**Guy Smith Stadium Improvements Phase 1  
Addendum No. 02**

<b>Project Name: Guy Smith Stadium Improvements</b>	<b>Project No.:</b> RFP#23-24-12
<b>Prepared By: Mark Nottingham</b>	<b>Date:</b> 08-30-2023

DESCRIPTION: Clarifications to Bidders  
PROJECT: 23-0176  
PROJECT NO. Guy Smith Stadium Improvements  
DOCUMENT DATE: 08/29/23

7' CHAINLINK FENCE  
NTS

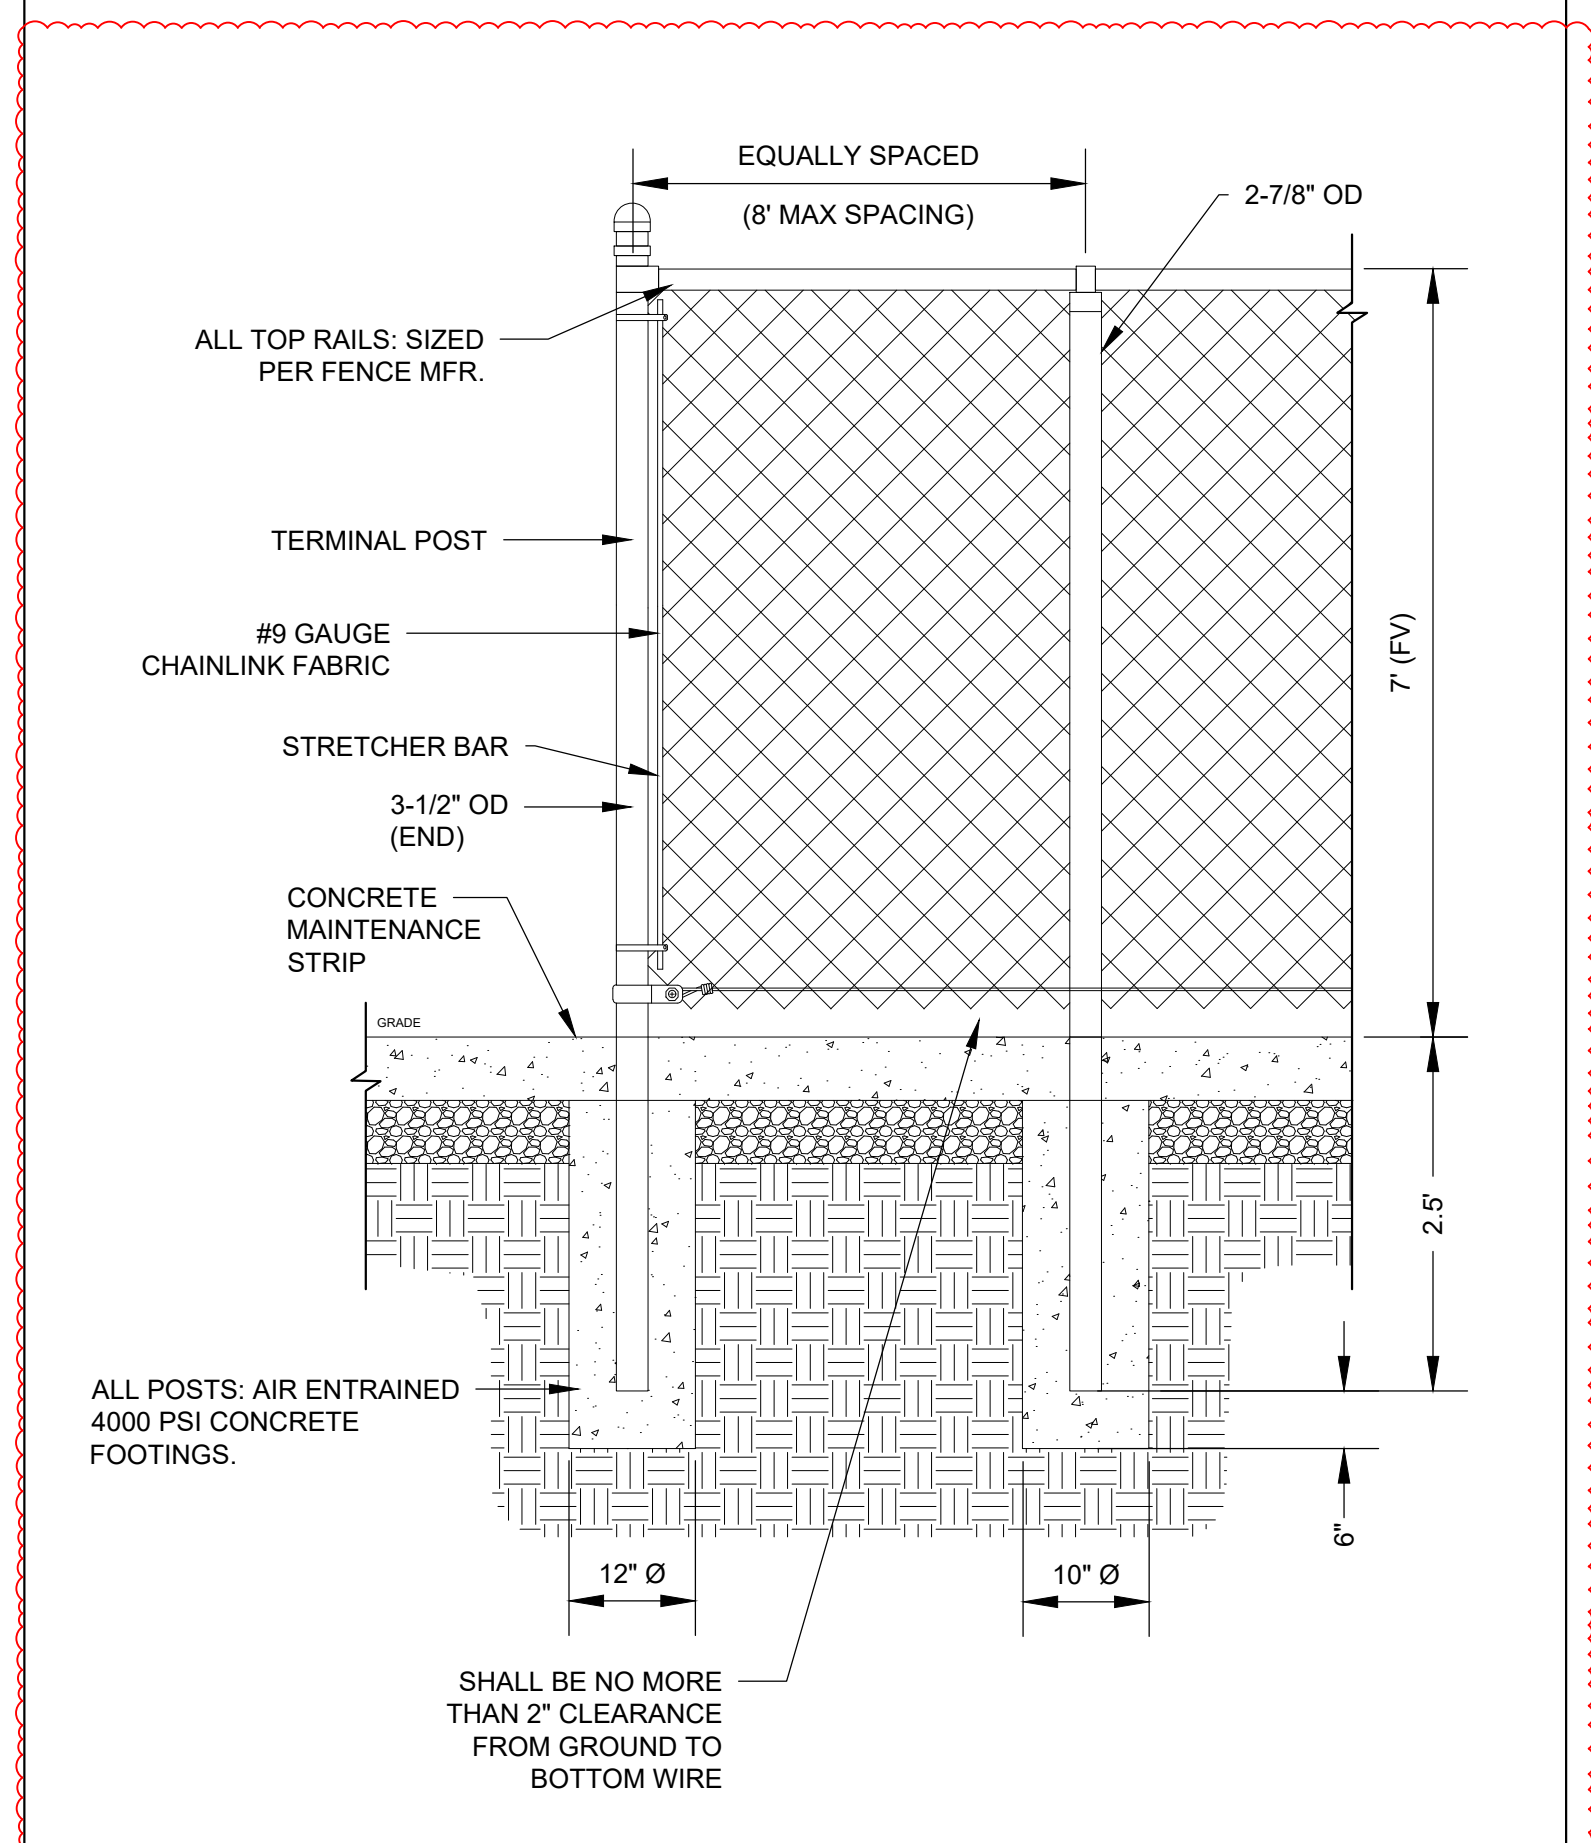
#### DETAIL – 7' CHAIN LINK FENCE

1. Removed vinyl coating callout, upgraded post and footing sizes due to privacy screen.
2. Removed any details referencing 8' fence, all fence on site is now either 4' or 7' tall. (Item #1)

4' WIDE X 7' SINGLE CHAINLINK SWING GATE  
NTS

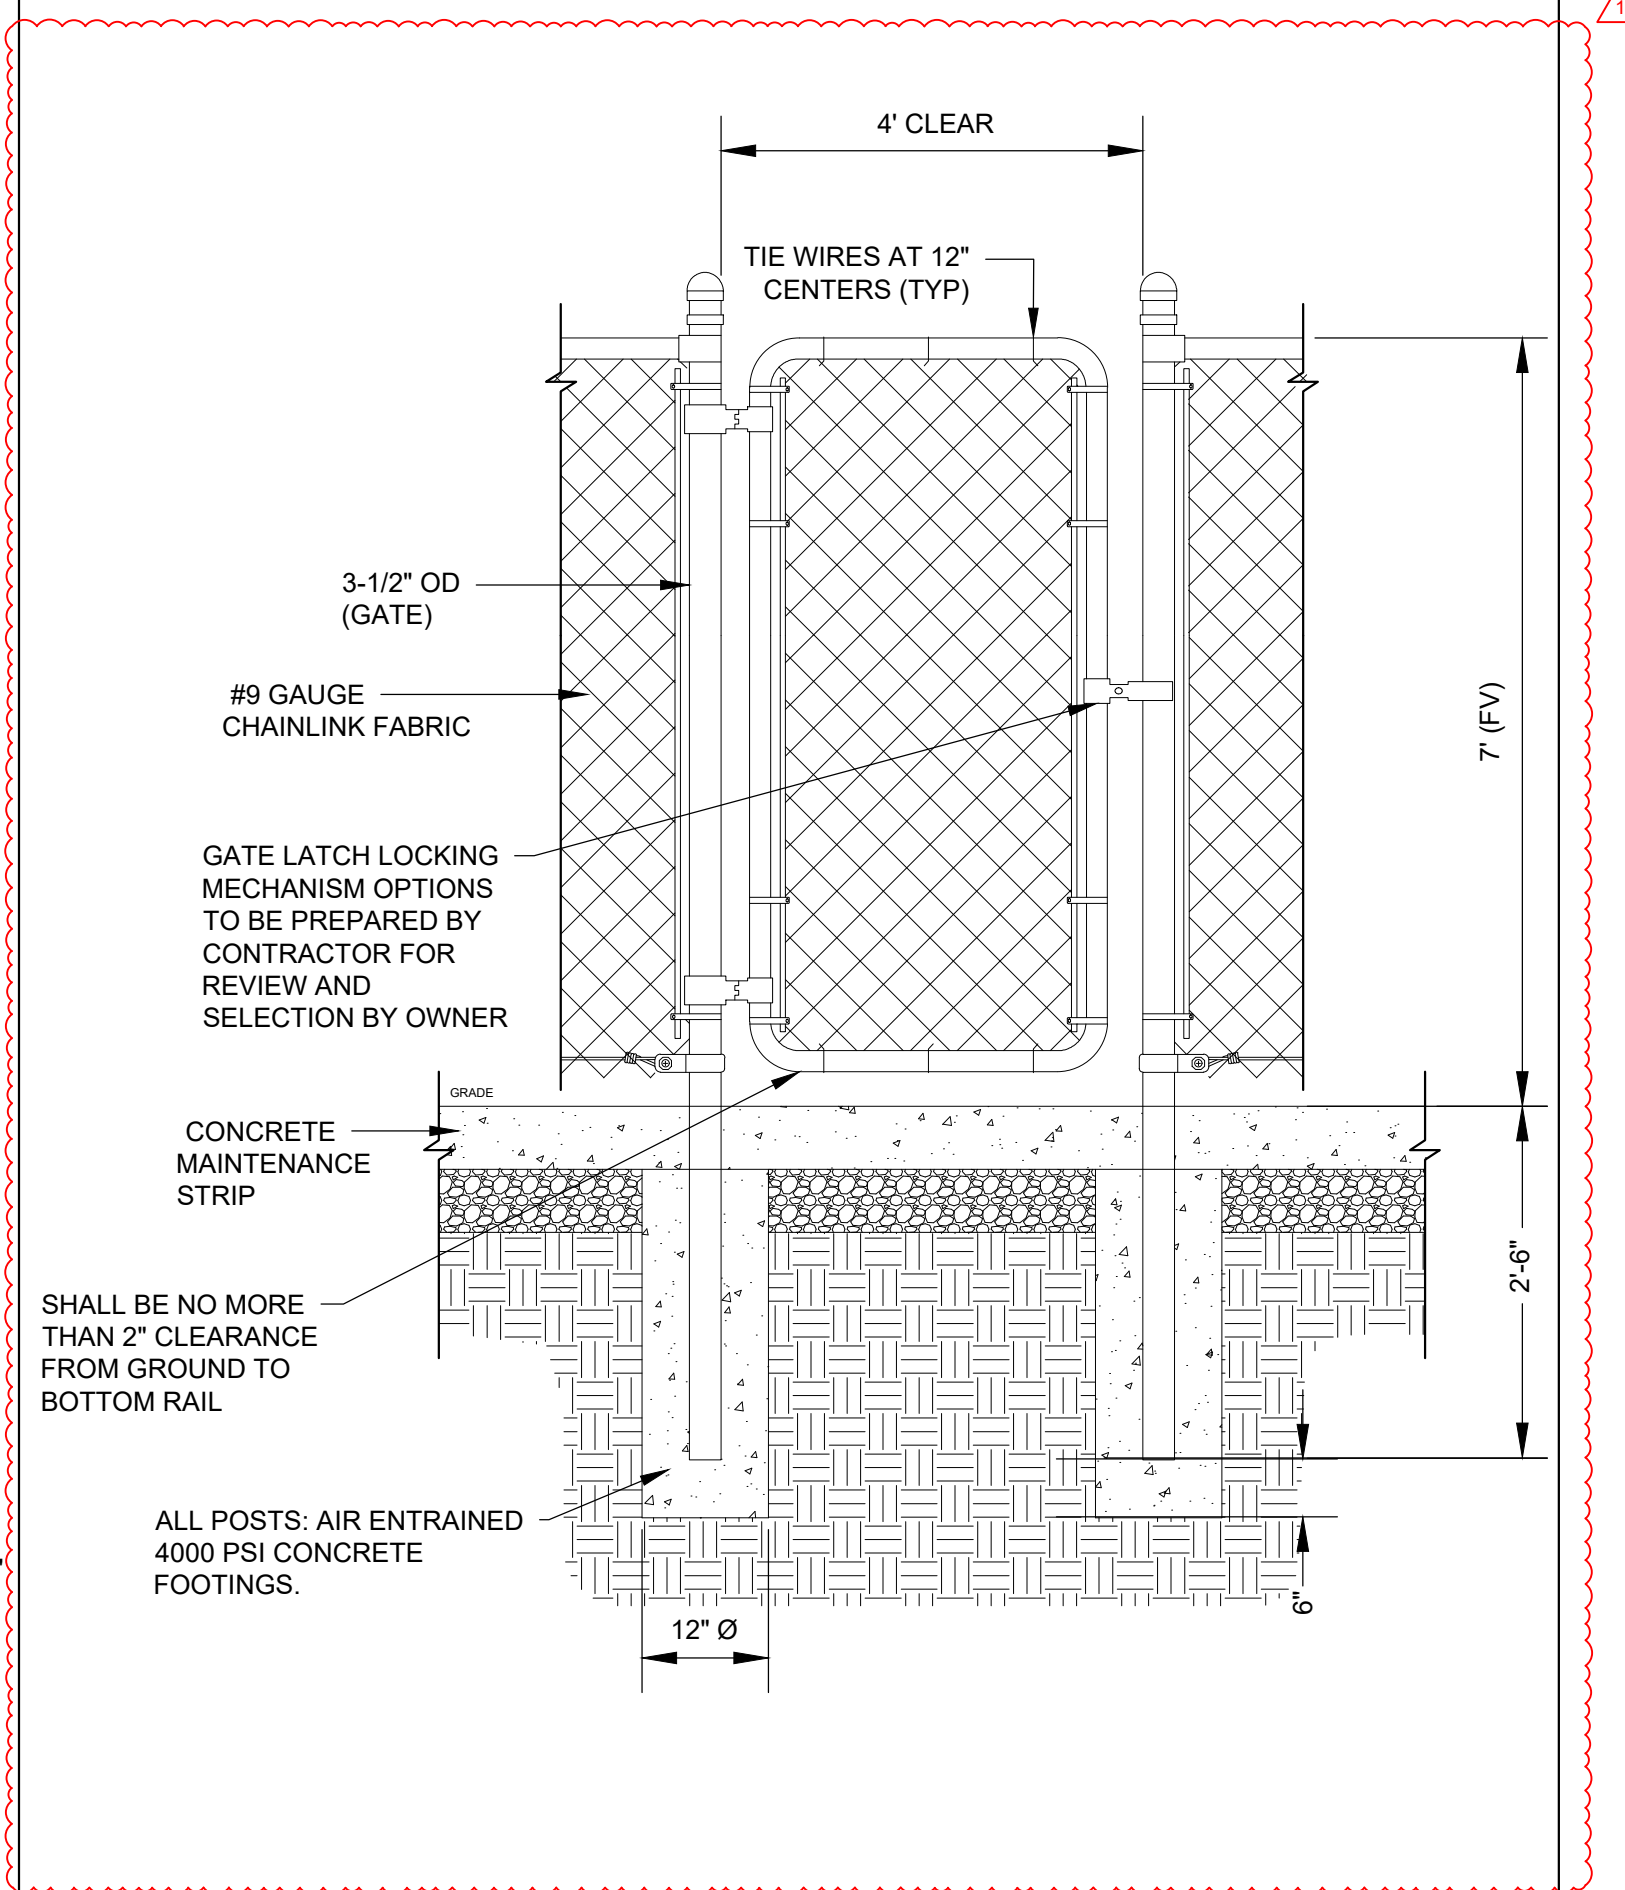
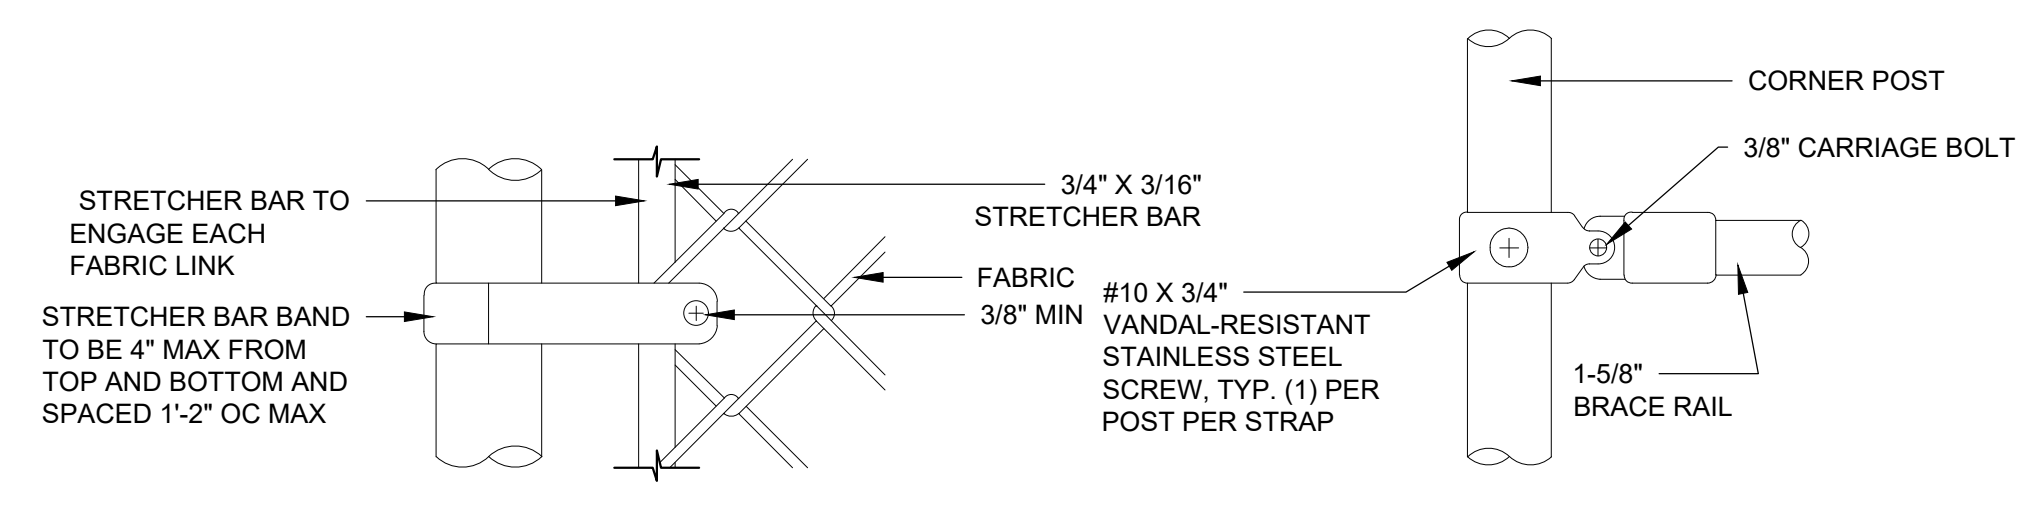
#### DETAIL – 4' WIDE X 7' DOUBLE CHAIN LINK SWING GATE

1. Removed vinyl coating callout, upgraded post and footing sizes due to privacy screen.
2. Removed any details referencing 8' fence, all fence on site is now either 4' or 7' tall. (Item #1)
